**KANSAS DEPARTMENT OF TRANSPORTATION
SPECIAL PROVISION TO THE
STANDARD SPECIFICATIONS, EDITION 2015**

SECTION 835

**RESEALING JOINTS AND SEALING CRACKS IN
EXISTING PCCP AND HMA PAVEMENTS**

**FIGURE 835-2: SEALING PCCP, SPALLED JOINTS AND CRACKS
($>2" \leq 3"$ wide, $\leq 1\frac{5}{8}"$ deep)**

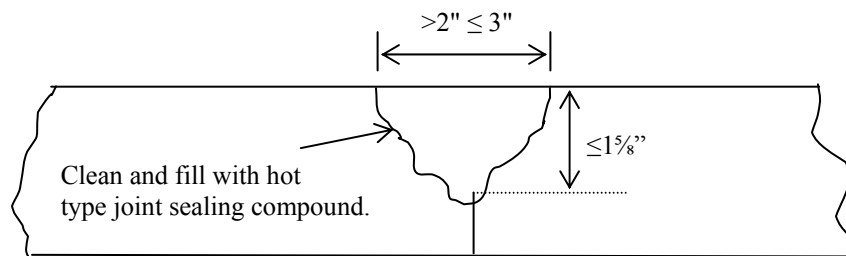
Page 800-94, replace FIGURE 835-2 with the following:

If the PCCP joints and cracks are 3 inches or less wide and 1 $\frac{5}{8}$ inches or less deep, fill the joints and cracks with hot type joint sealing compound. See **FIGURE 835-2**. Fill the joints and cracks to a level slightly recessed from the pavement surface.

FIGURE 835-4: TYPE B, SEALING PCCP, SPALLED JOINTS AND CRACKS (>2" ≤ 3" wide, >1 5/8" deep)

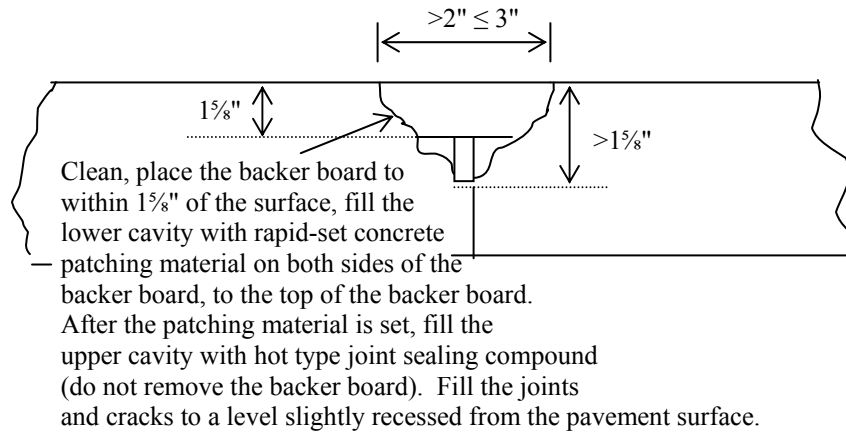
Page 800-94, replace FIGURE 835-4 with the following:

FIGURE 835-5: SEALING ASPHALT PAVEMENT CRACKS (>1/8" < 2")

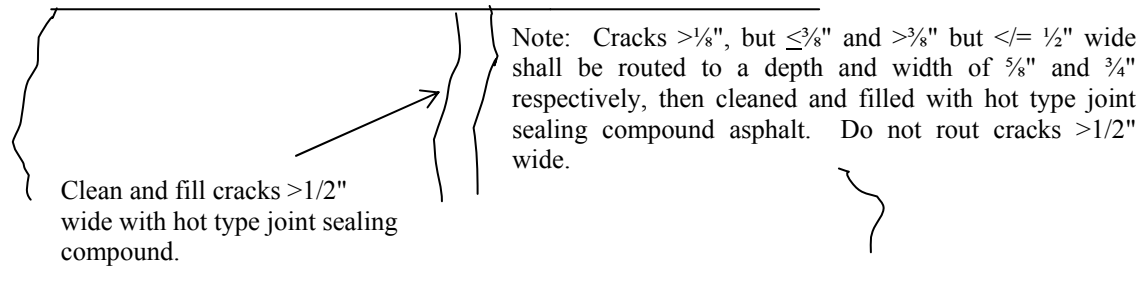
Page 800-95, replace FIGURE 835-5 with the following:

Fill the routed cracks (1/8 to 1/2 inch) and the un-routed cracks (wider than 1/2 inch) with hot type joint sealing compound. Fill all cracks to a level slightly recessed from the pavement surface.
